Product Change Notice (PCN)

Subject: Add Alternate Fab Location

Publication Date: 6/30/2026

5PB1102PGGI/5PB1102PGGK/5PB1104PGGI/5PB1104PGGK

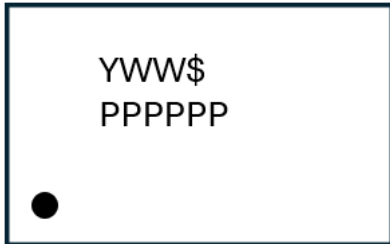
Refer to the top mark stepping number “#” as outlined in the Affected Product List table. Renesas is revising the marking format for parts that do not presently contain a stepping number:

Current Markings

- Line 1: Y = Last digit of the year
 - WW = Workweek
 - \$ = Single Char assembly code Line
- Line 2: Truncated Product Name

5PB1102PGGI/5PB1102PGGK/5PB1104PGGI/5PB1104PGGK

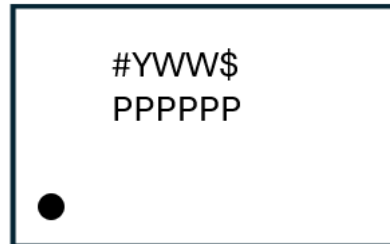
New Markings

- Line 1: # = Device stepping
 - Y = Last digit of the year
 - WW = Workweek
 - \$ = Single Char assembly code Line
- Line 2: Truncated Product Name

9DBL0255NLGI

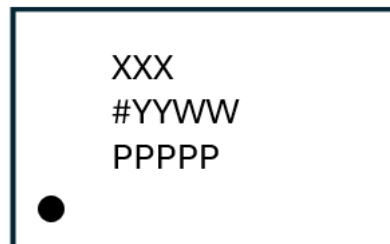
- Line 1: XXX is last 3 digits of assembly lot no
- Line 2: YY = last 2 digit of year
 - WW = Workweek
- Line 3: Truncated Product Name
